MONTGOMERY COUNTY HISTORIC PRESERVATION COMMISSION
STAFF REPORT

Address:	3717 Bradley Lane, Chevy Chase	Meeting Date:	4/3/2024
Resource:	<i>Master Plan Site #35/68,</i> Mills House	Report Date:	3/27/2024
Applicant:	Abigail Barnes (Chris Scango, Agent)	Public Notice:	3/20/2024
Review:	HAWP	Tax Credit:	No
Case #:	1061611	Staff:	Chris Berger
PROPOSAL:	Driveway removal.

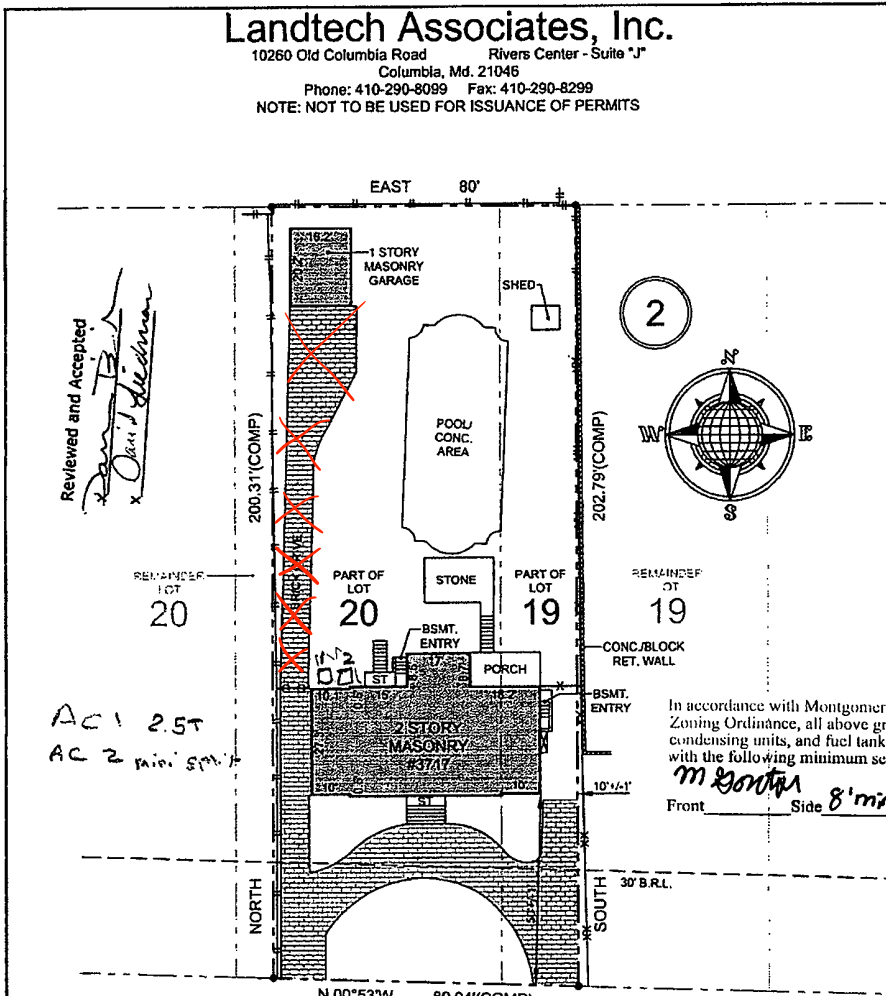
Staff has the following questions:

- What is the approximate length and width of the asphalt driveway to be removed?
- Will the concrete curb along the right side of the driveway also be removed?
- Do you plan to install a new access path to the garage as part of a future HAWP application?

Great, thank you for the update! The asphalt driveway is approximately 98 feet long. It is mostly 8 feet wide but 17 feet wide by the garage.

Yes, we plan to remove the concrete curb as well.

We have no plans to install a new driveway at this time.
